# Access Compliance Report Public Rights-of-Way (Curb Ramps)

Intersection ID: 7344	Main Street: LOG_CABIN_RD	Cross Street: TOM_HUNTER_RD	Location: SW
ADA ID: BD171FB03694	Ramp Type: PerpDiag	Initial Pass/Fail: Fail	Overall Compliance: No Severity Score: 10

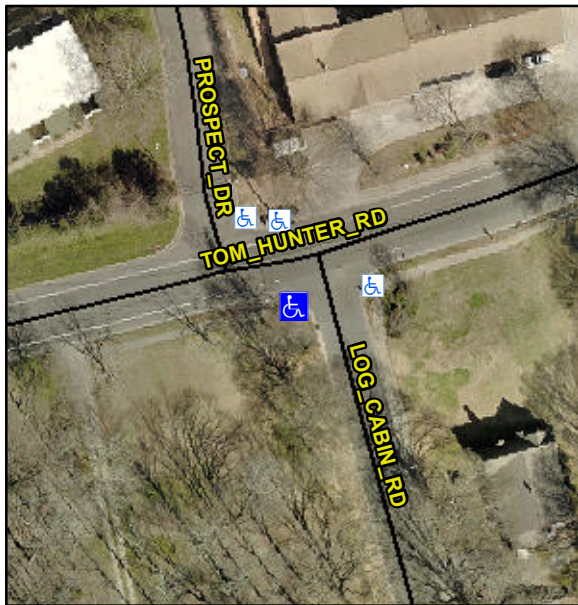
**Not Found, R304.5.1, R304.5.3**

Compliance	Description	Data	Compliance	Description	Data
N/A	Ramp Length (in)	47.0	Yes	Ramp Slope (%)	7.9
No	Ramp Width (in)	47.0	No	Ramp XSlope (%)	2.7
N/A	Flare Type LT	N/A	N/A	Flare Type RT	N/A
N/A	Flare Slope LT (%)	N/A	N/A	Flare Slope RT (%)	N/A
N/A	Flare Traversable LT?	N/A	N/A	Flare Traversable RT?	N/A
N/A	Landing Length (in)	N/A	N/A	DWS Provided?	N/A
N/A	Landing Width (in)	N/A	N/A	DWS Contrast?	N/A
N/A	Landing Slope (%)	N/A	N/A	DWS Length (in)	N/A
N/A	Landing X Slope (%)	N/A	N/A	DWS Full Width?	N/A
N/A	Landing Curb? (Y/N)	N/A	N/A	DWS Offset (in)	N/A
N/A	Shared Landing?	N/A			
N/A	Gutter Ponding?	N/A	N/A	Gutter Slope (%)	N/A
N/A	Gutter Lip Ht (in)	N/A	N/A	Gutter X Slope (%)	N/A
N/A	Painted X Walk1?	No	N/A	Painted X Walk2?	No
	X Walk 1 Direction	To E		X Walk 2 Direction	To N
N/A	X Walk 1 Width (in)	N/A	N/A	X Walk 2 Width (in)	N/A
	X Walk 1 Slope (%)	1.9		X Walk 2 Slope (%)	0.8
	X Walk 1 X Slope (%)	0.7		X Walk 2 X Slope (%)	0.2

**Remove & Replace Curb Ramp With Two New Directional Ramps or Equivalent.**
